Subject: Notification of Class 1 Permit Modification Updates Associated with the Technical Area 63 Transuranic Waste Facility Container Storage Unit of the Los Alamos National Laboratory (LANL) Hazardous Waste Facility Permit, EPA ID # NM0890010515

Enclosures: (1) Class 1 Permit Modification Notification Updates for the Technical Area 63 Transuranic Waste Facility Container Storage Unit, Los Alamos National Laboratory Hazardous Waste Facility Permit

Class 1 Permit Modification
Notification Updates for the
Technical Area 63 Transuranic Waste Facility
Container Storage Unit,
Los Alamos National Laboratory
Hazardous Waste Facility Permit

Figure 4: Storage Building Fire Protection Plan

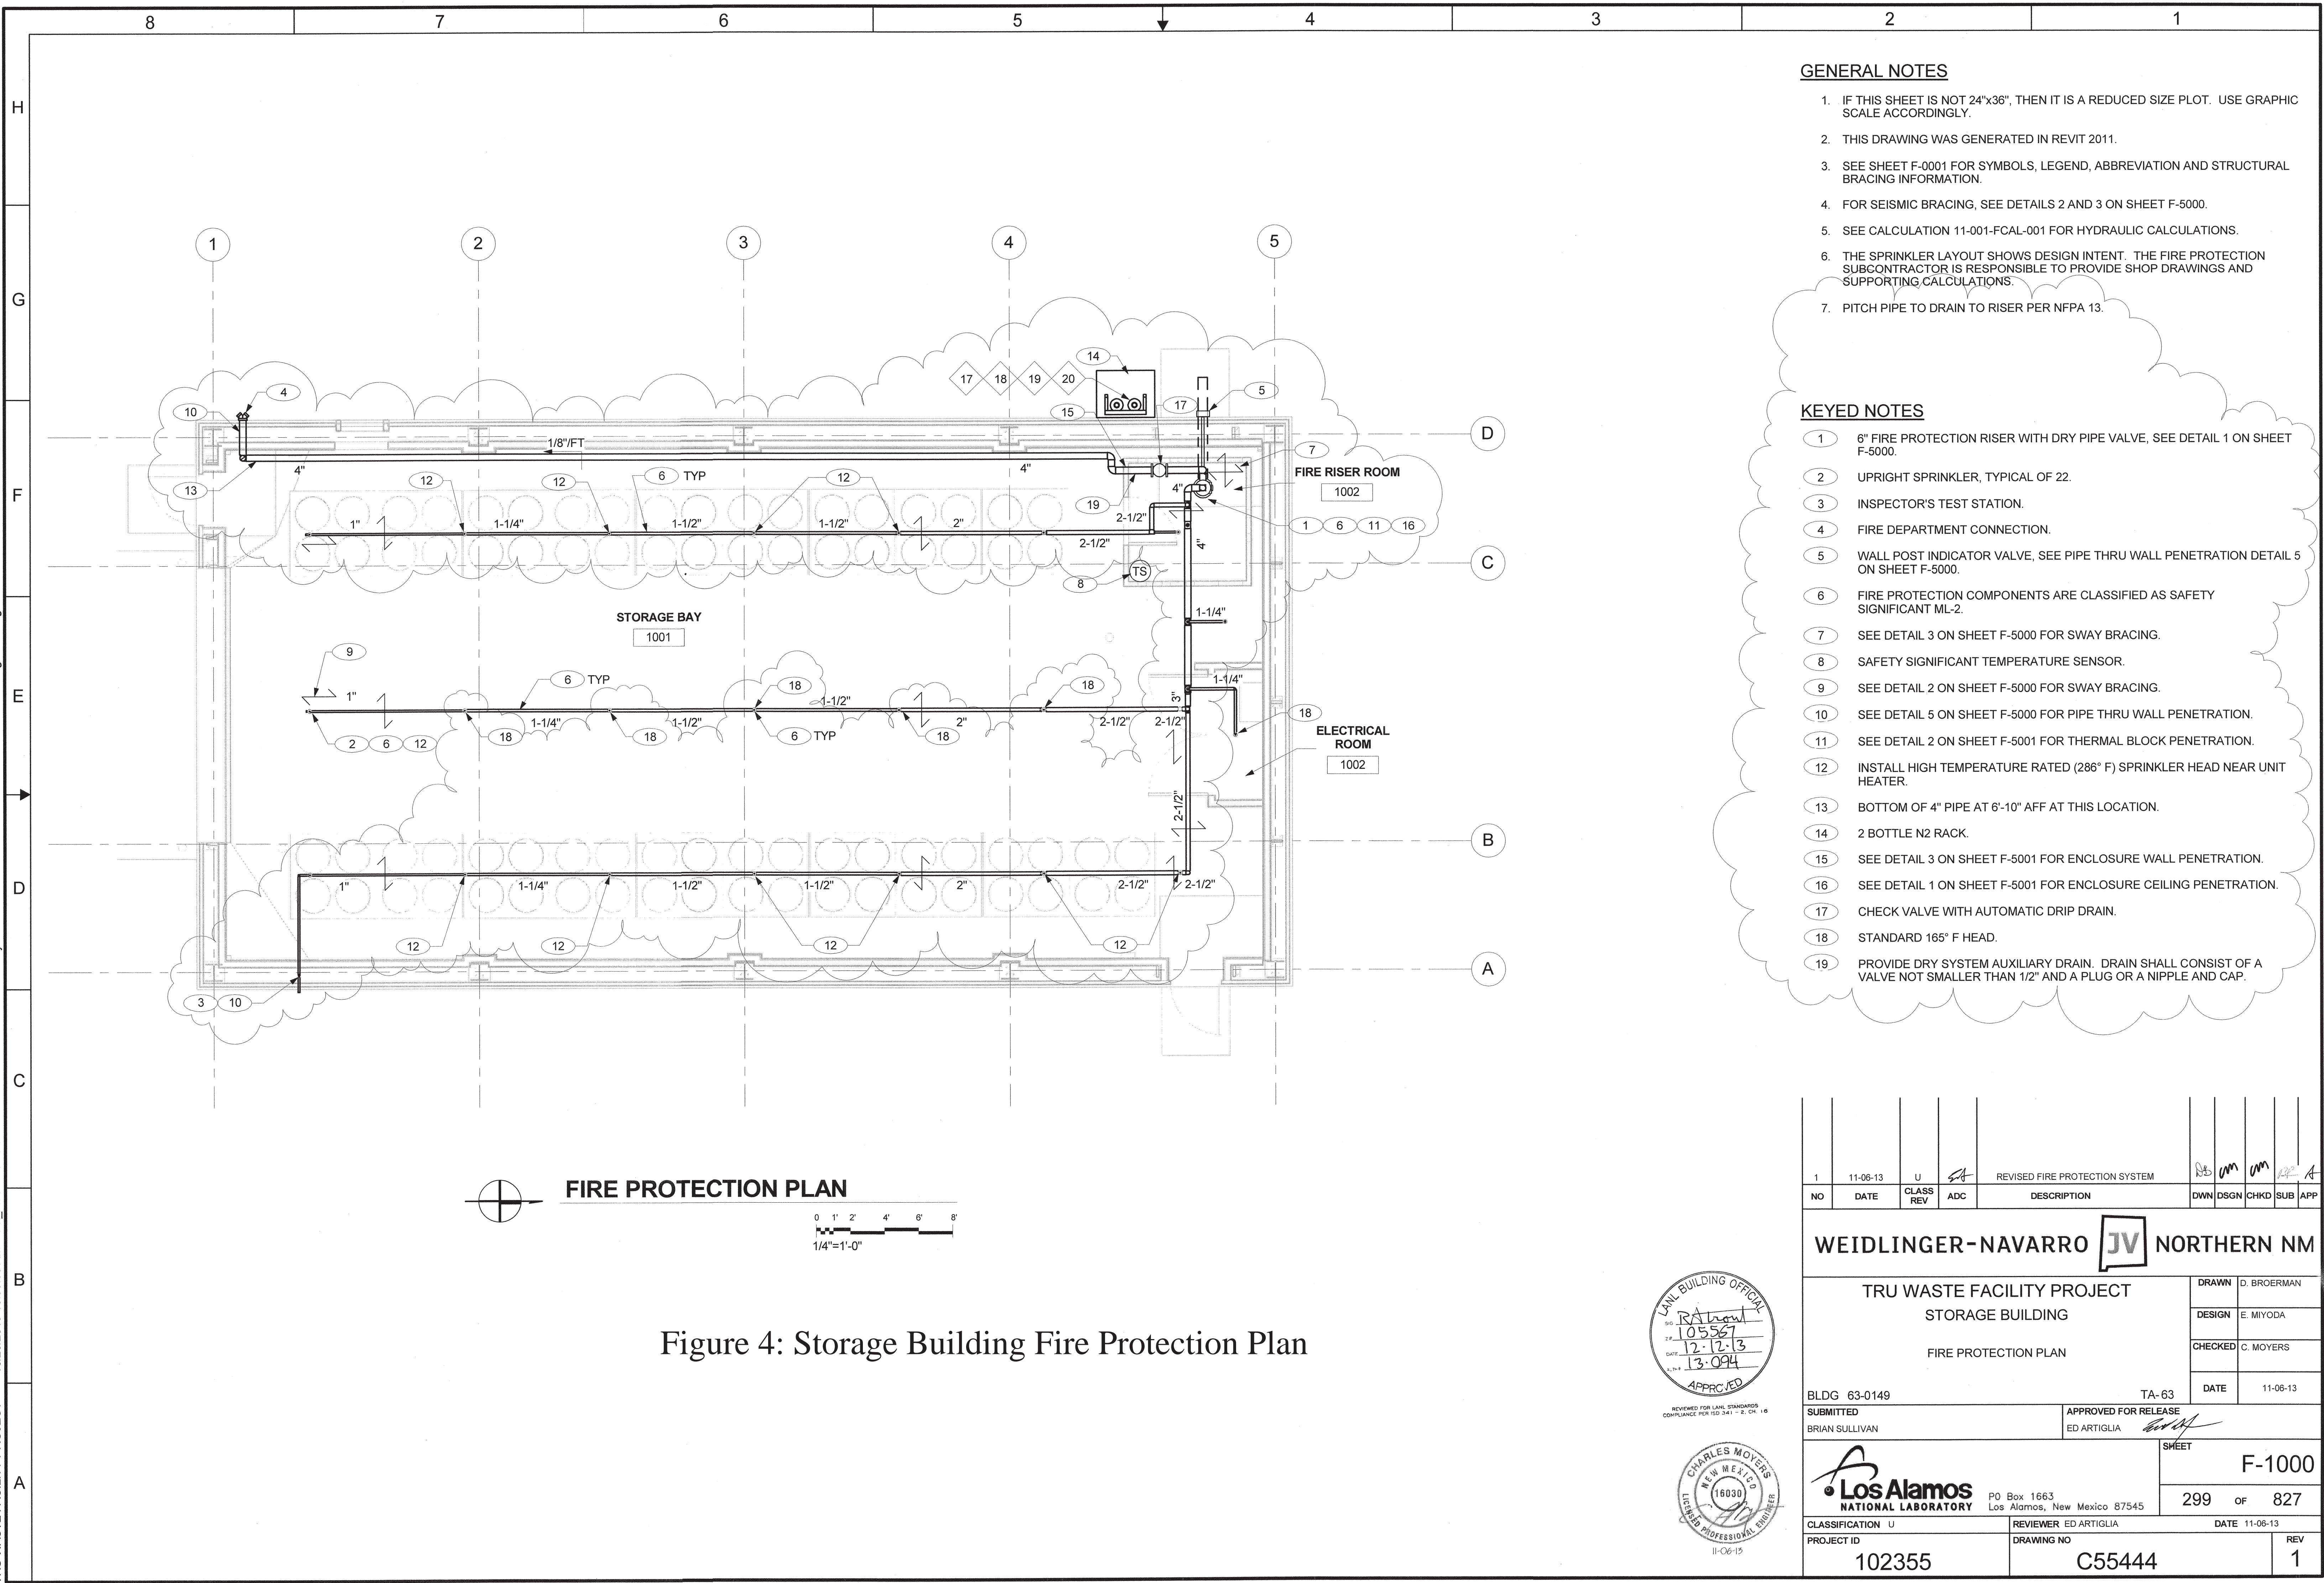
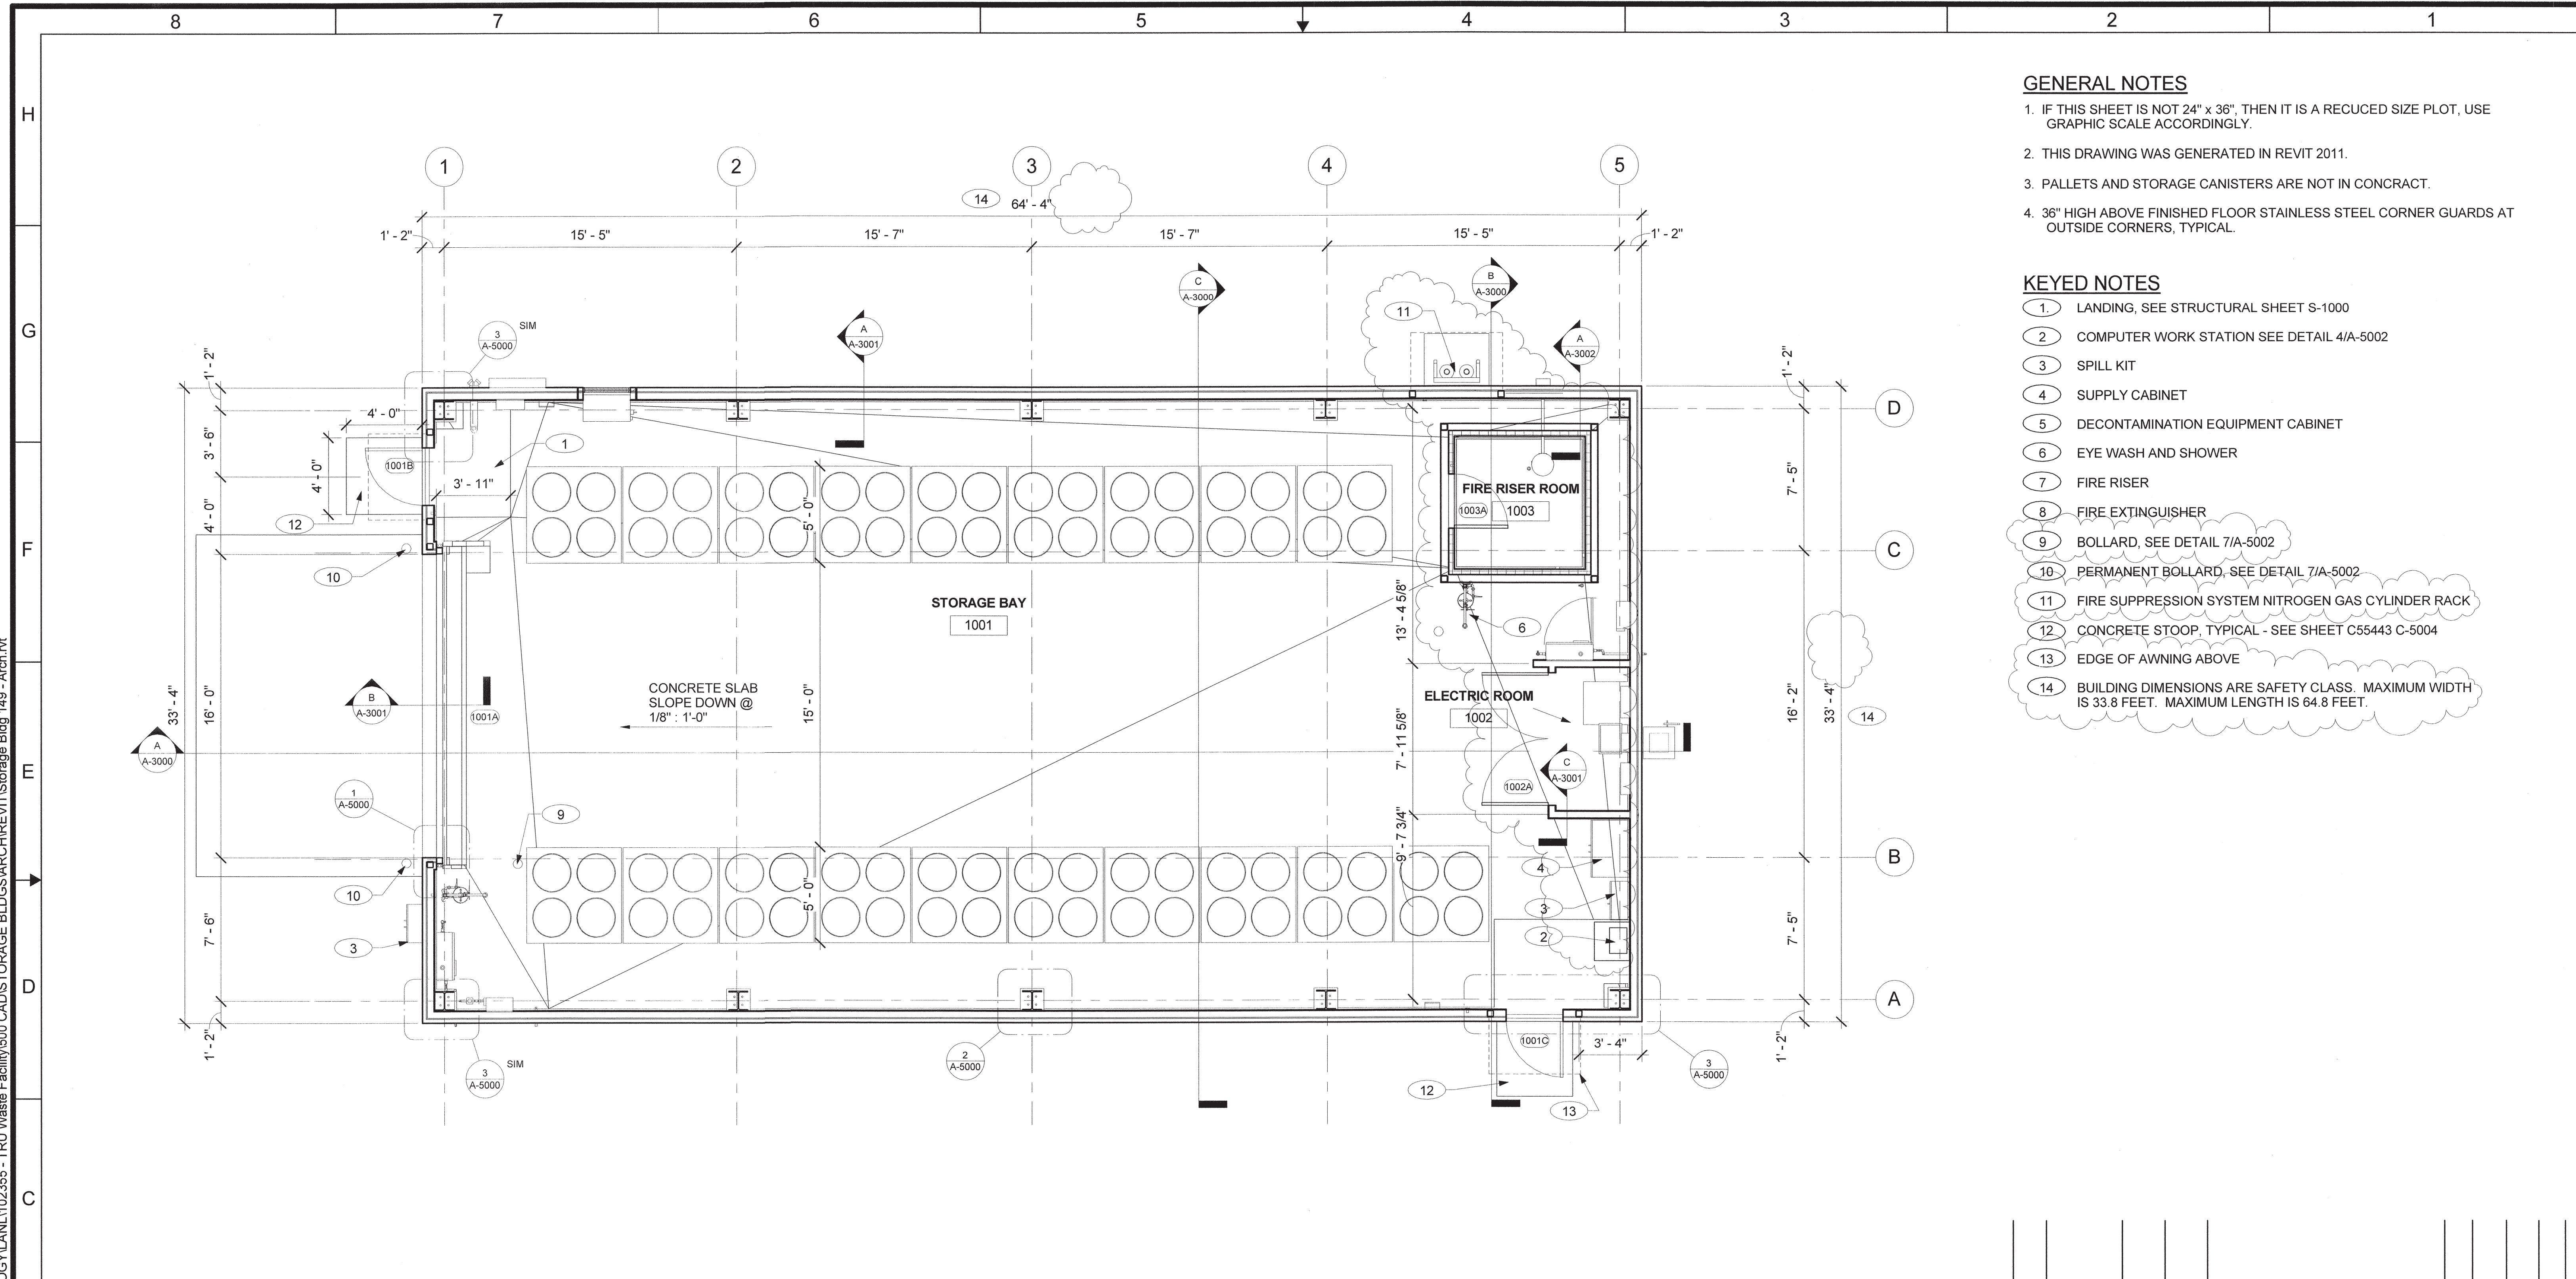
There has been a design revision for the fire suppression system within the storage buildings at the TA-63 TWF involving a substitution in the fire suppression equipment to be used at the facility. Originally, a wet pipe system was described in the TWF Permit Modification Request (PMR) submitted to the NMED-HWB by the Permittees (*Permit Modification Request for Technical Area 63 Transuranic Waste Facility Hazardous Waste Container Storage Unit*, Rev. 3.0, LA-UR-12-24928, October 2012). This has been changed to a dry pipe system. The purpose of the change is to improve firefighting capabilities in the storage buildings and to prevent the possibility of fire water being released from the system in the event of freezing.

The above discussion supports the replacement of the descriptive term “wet pipe” to “dry pipe” for the fire suppression equipment described in Permit Attachment A.6. This design change also affects Figures 2-9, 2-16, 2-17, 2-19, 2-27, and 2-28 originally submitted with the TWF PMR. Those figures described the plan layout of the storage buildings and the original details of the fire suppression water distribution systems. New and revised figures have been included with this submittal in Attachment 1 (*see* Figures 3-14) to support the administrative record for the project by providing the new and revised information. The revisions from the original figures are limited to adding final enclosures for the dry pipe valving to the storage building plan layouts and adding the dry pipe valving components to the existing water distribution piping systems. The purpose of the enclosures for the dry pipe valving will be to contain the valving and heating equipment. The enclosures will not be a structural addition to the storage buildings.

Descriptions, Permit Section A.6.8, *Required Equipment*. In the fourth paragraph on page 44 of Attachment A, it is stated that: “Fire protection systems for the TWF storage buildings, including the Storage and Characterization Building 63-0154, include a wet pipe sprinkler system for fire suppression.” The description of the sprinkler system has been altered to “dry pipe.” The description of the fire suppression system in the Fire Control Equipment Section of Permit Table D-5, *TA-63 Transuranic Waste Facility Emergency Equipment*, does not require this change.
